North Sydney Council
PO Box 12
NORTH SYDNEY NSW 2059

14th August 2023

Re: Young Street and Grosvenor Street Intersection - Cycling and Walking Upgrades

Figure 1: Extract from North Sydney Integrated Cycling Strategy, 2014 showing priority routes. The area affected by the proposal is indicated with the grey circle; the extension to the Young Street cycleway is in dashed orange (Source: North Sydney Council / GTA Consultants)

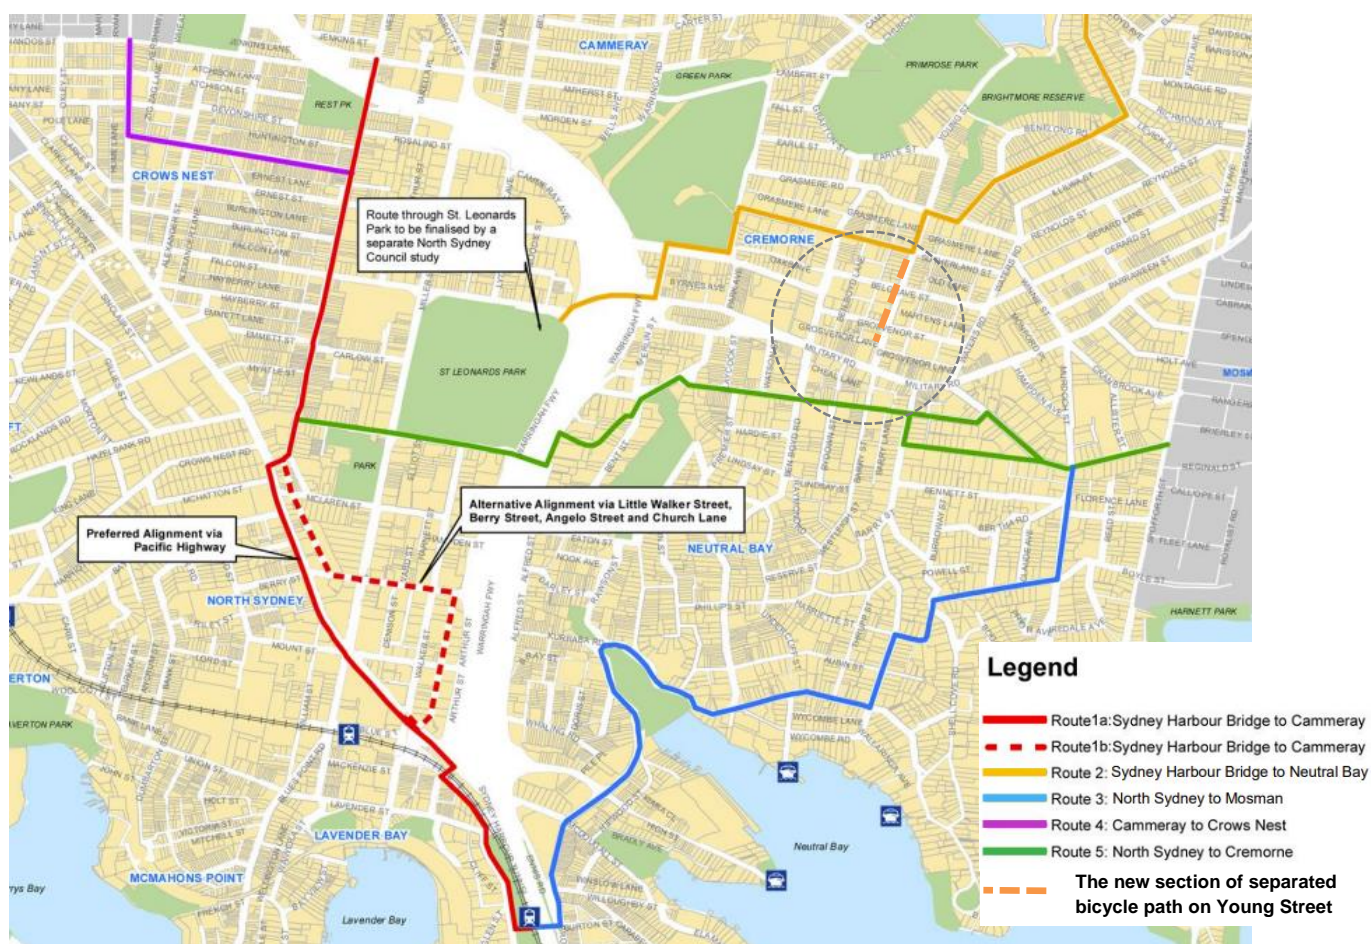
The extension of the Young Street protected bicycle path to Neutral Bay Village (Figure 1) will improve accessibility for people using active modes to visit the shops. The changes to the intersection prioritise walking and cycling and make it easier to leave the car at home (Figure 2).

4. It is important to clarify how the Young St cycleway integrates into a north-south crossing of Military Rd. Although a connection across Military Road is not part of the 2014 Cycling Strategy (Figure 1), a link to Yeo Street from the extended Young Street cycleway would be very desirable.
